<b>REPORT TO</b>	Statutory Planning Committee		
<b>Meeting date</b>	20 November 2018	<b>File number</b>	156906
<b>Subject</b>	Subdivision to Create 1,940 Lots and 17 Reserves - Various Lots Barragoon Road, Caraban, Moore River South		
<b>Purpose</b>	Requires WAPC decision		
<b>Title of Approving Officer</b>	A/Assistant Director General, Land Use Planning		
<b>Agenda Part for Reports</b> SPC - Non-Confidential (To be published to the website)			
<b>SITE-SPECIFIC DETAILS</b>			
<b>Region/s</b>	Wheatbelt		
<b>Local government/s</b>	Shire of Gingin		
<b>Landowner: Consultant:</b>	Moore River Company Pty Ltd - Marcus Plunkett & Graeme Sampson Creative Design + Planning - Denise Morgan & Chee Mok		
<b>Location map</b>	Attachment 1 - Locality plan		
<b>Bushfire Prone Area</b>	YES		
<b>Statutory Planning Committee</b>			
<b>Local Scheme Zoning</b>	Future Development and General Rural		
<b>Council's recommendations</b>	Approve subject to conditions

<b>Receipt date</b>	29 June 2018	<b>Process days</b>	144 (with deferral)
<b>Property Address</b>	Lots 2593, 3156, 2802, 2914, 2424 and 3099 Barragoon Road, Caraban		
<b>SUMMARY</b>			
<p>The application proposes the subdivision of Lots 2424, 291

**Scale: 1:2,000 @ A1**  
 0 20 40 60  
 PLAN: MRCUR-3-002E REVISION: E  
 DATE: 30/10/2018 DRAWING: RF

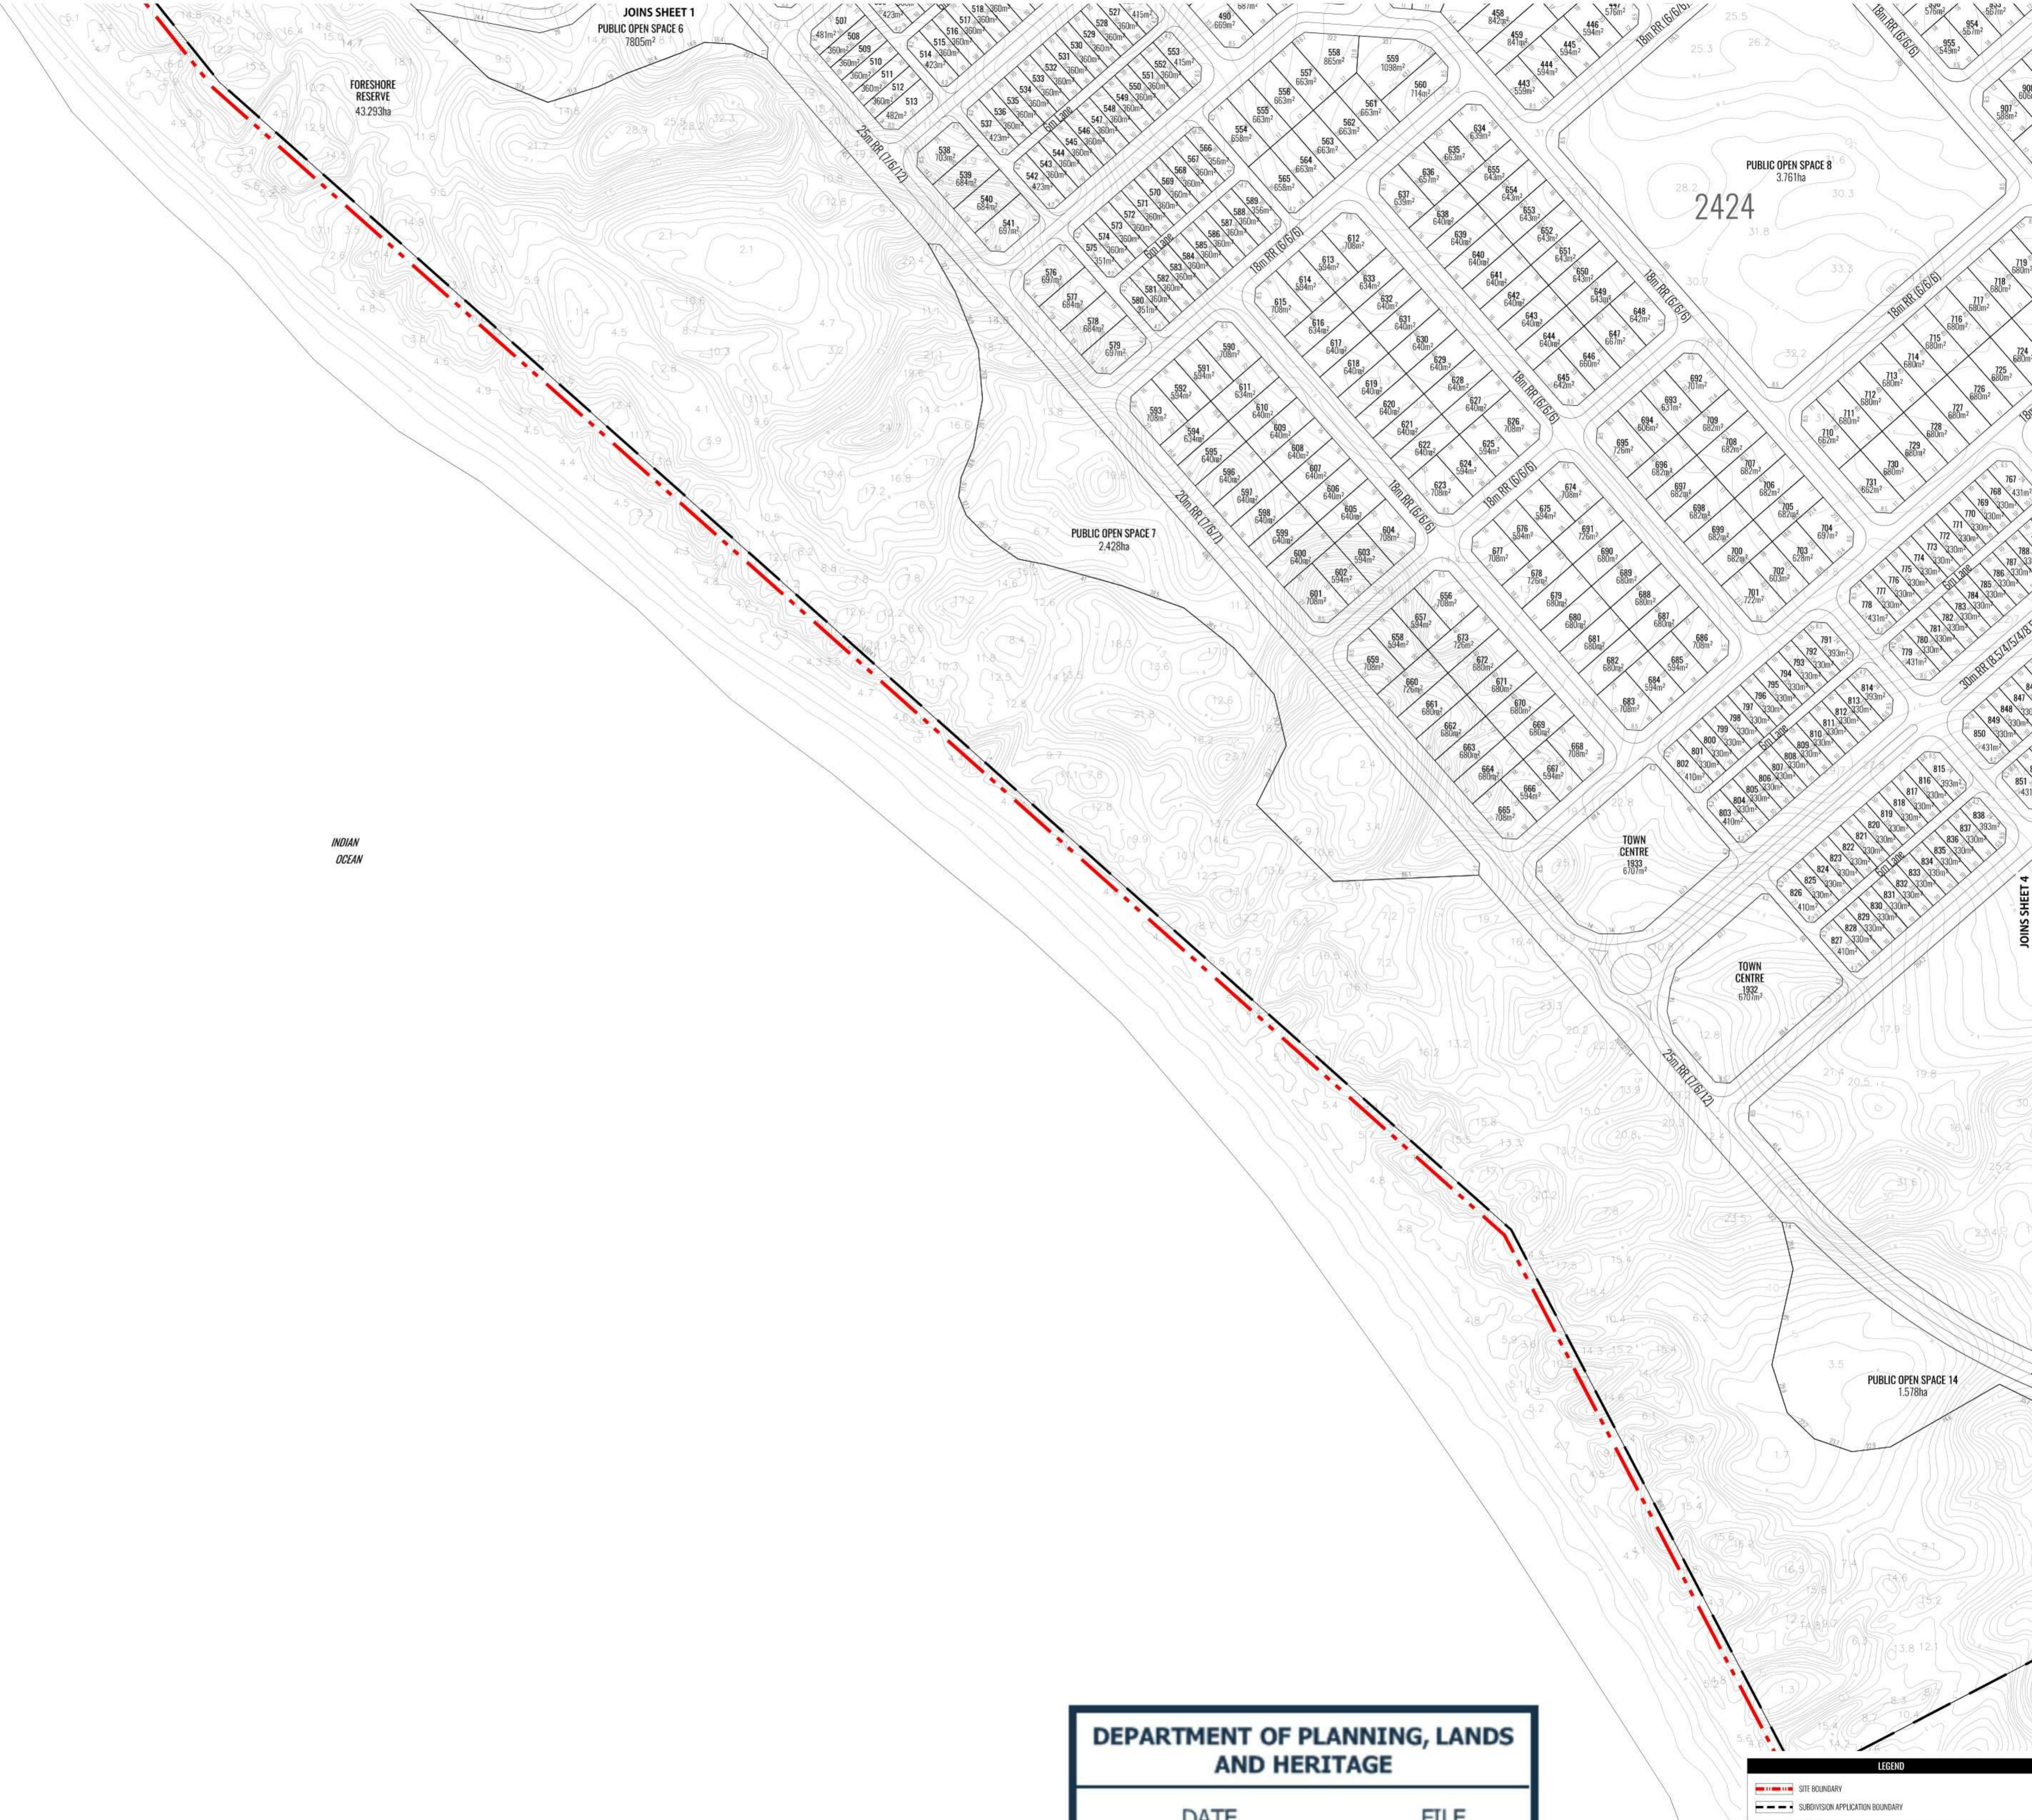
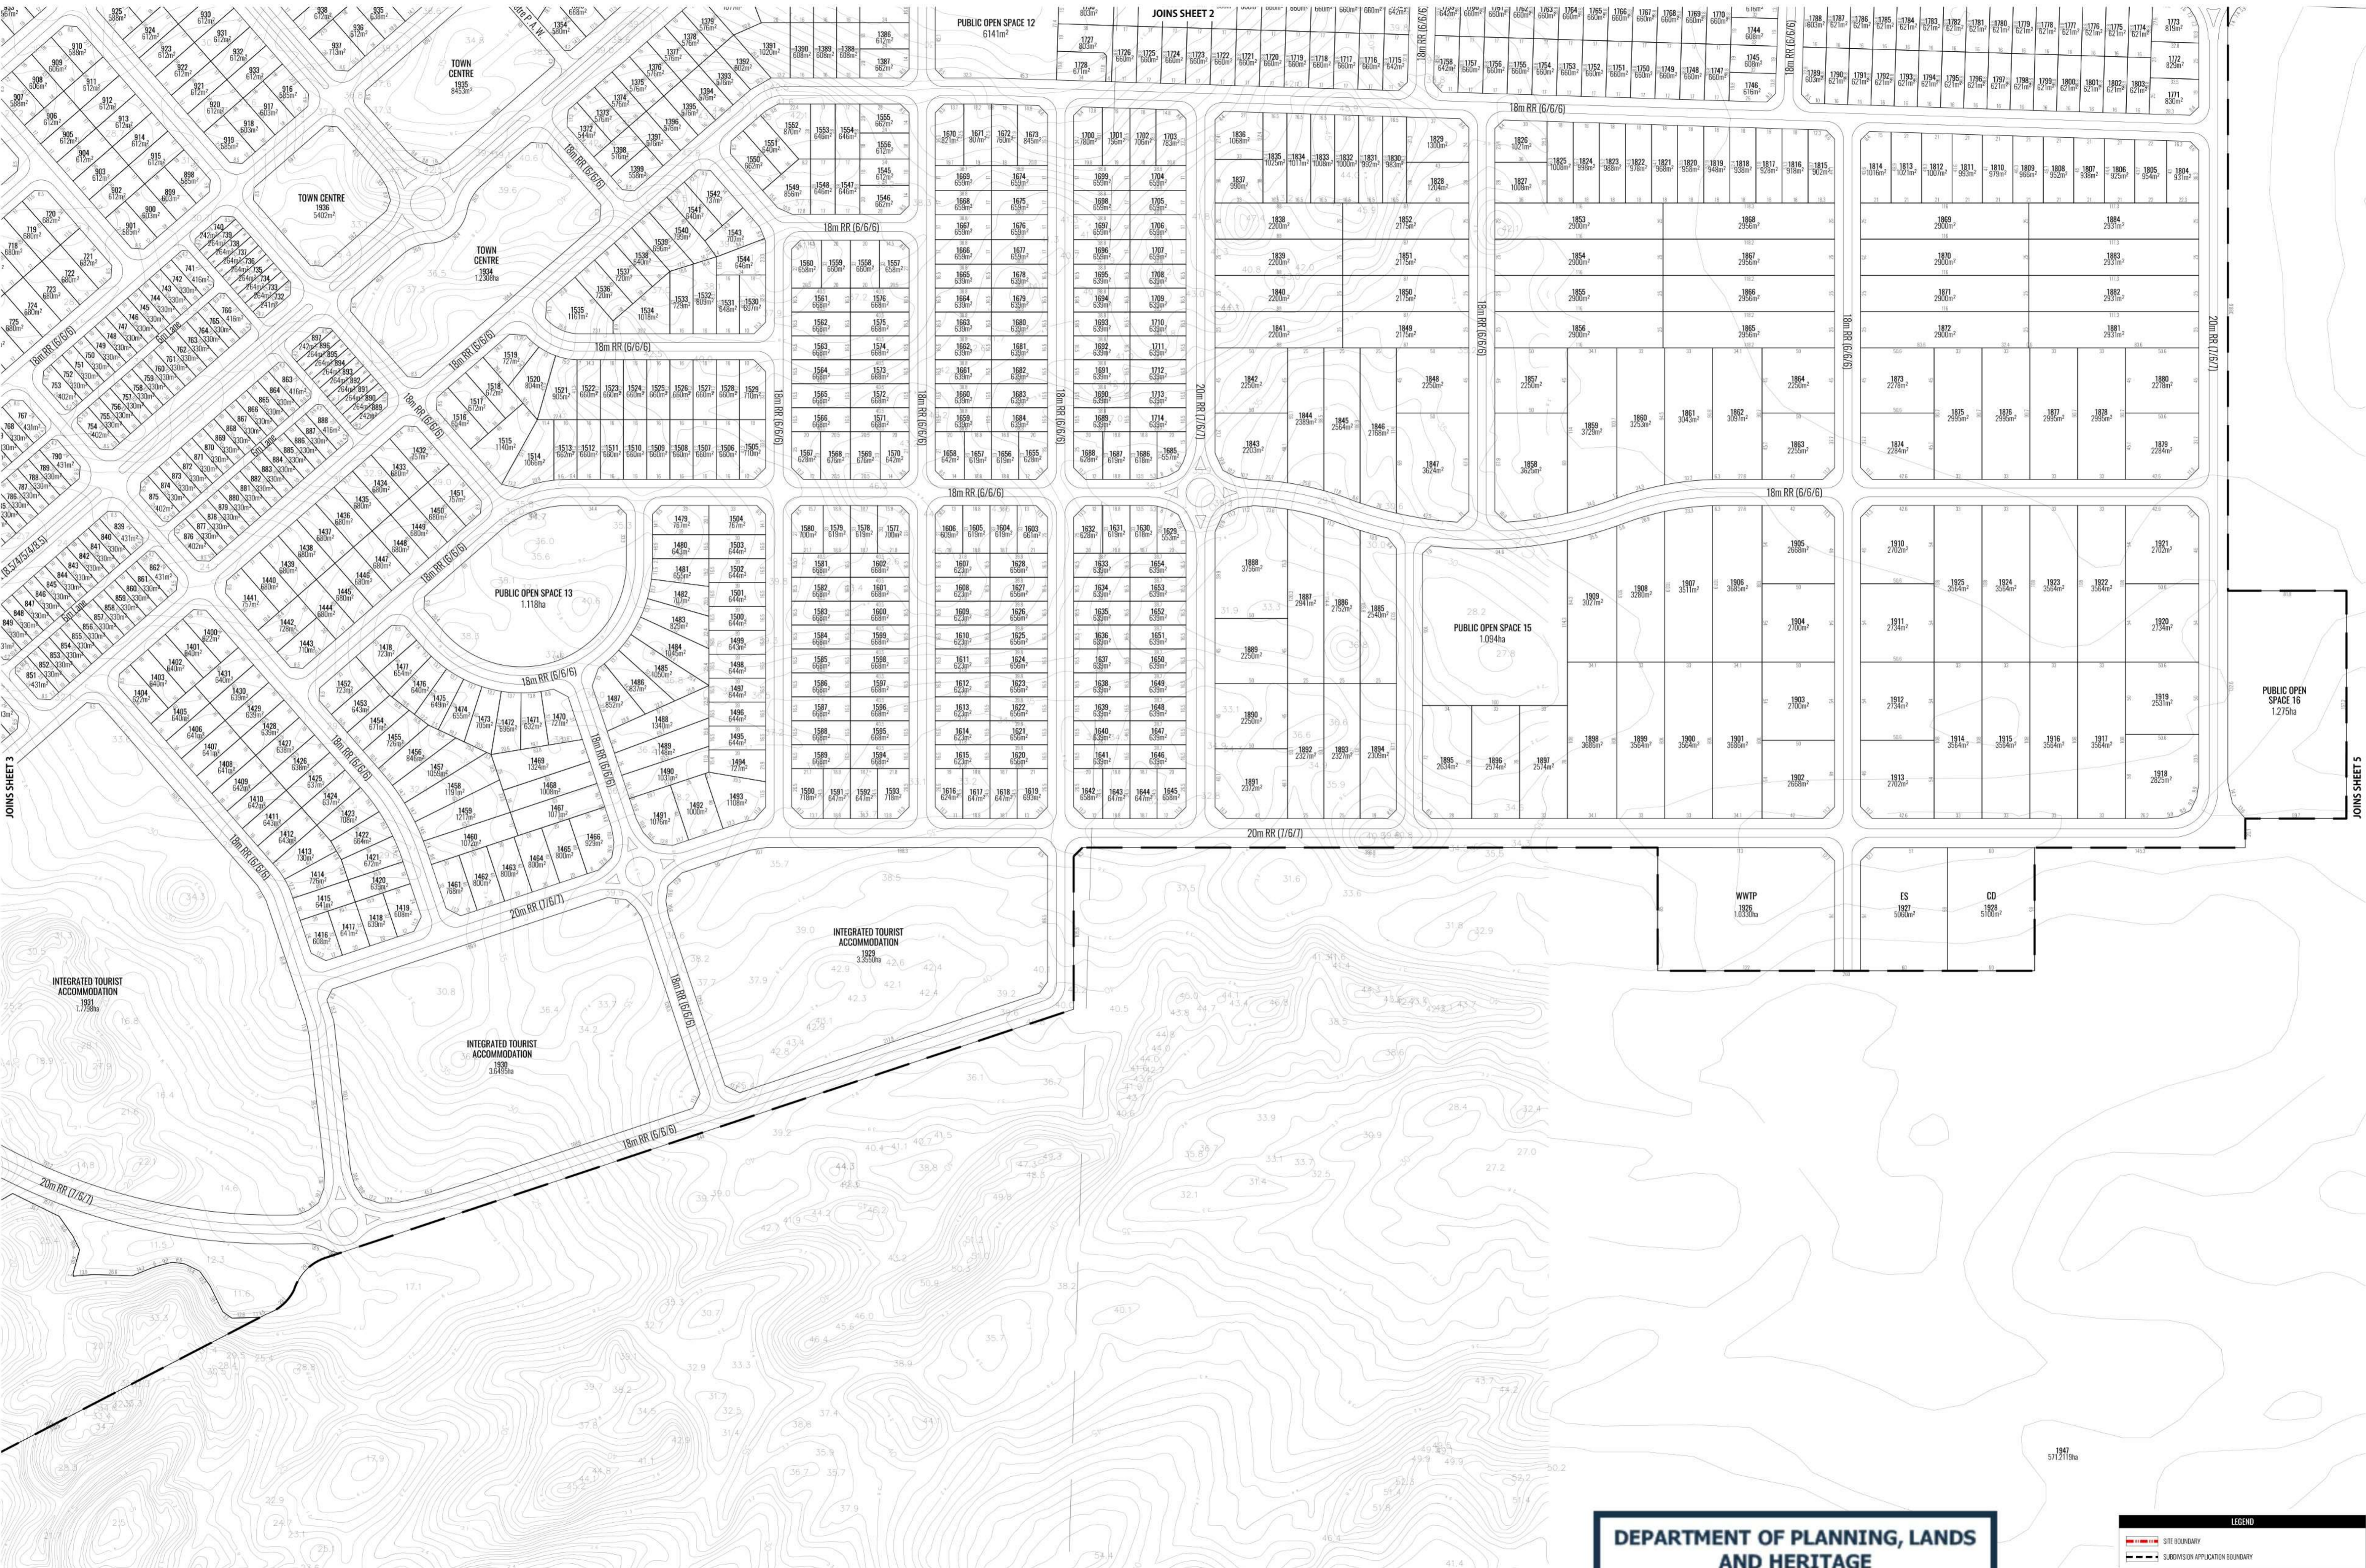
Concerns regarding road hierarchy, access onto Indian Ocean Drive and the size of the primary school site were raised through the referral process. The applicant has submitted a modified subdivision plan dated 30 October 2018 (**Attachment 2**) and supporting information to respond to referral advice and State policy requirements.

Modifications to the plan have included lot reconfiguration to allow for widening of the foreshore reserve, a primary school site sufficient to accommodate future needs, the addition of a site containing significant tree habitat as a conservation reserve, the addition of public open space reserves (3), the addition of infrastructure lots for sewerage and groundwater services (4) and the alteration of road reserves to accommodate suitable road widths and truncations. This has resulted in the addition of 13 residential lots, 1 town centre lot and 1 tourism lot, the amalgamation of two rural lots and the removal of 4 mixed business lots.

- 1. The plan of subdivision is to be modified in accordance with the attached plan dated 30 October 2018 (Attachment 2). (Western Australian Planning Commission)***
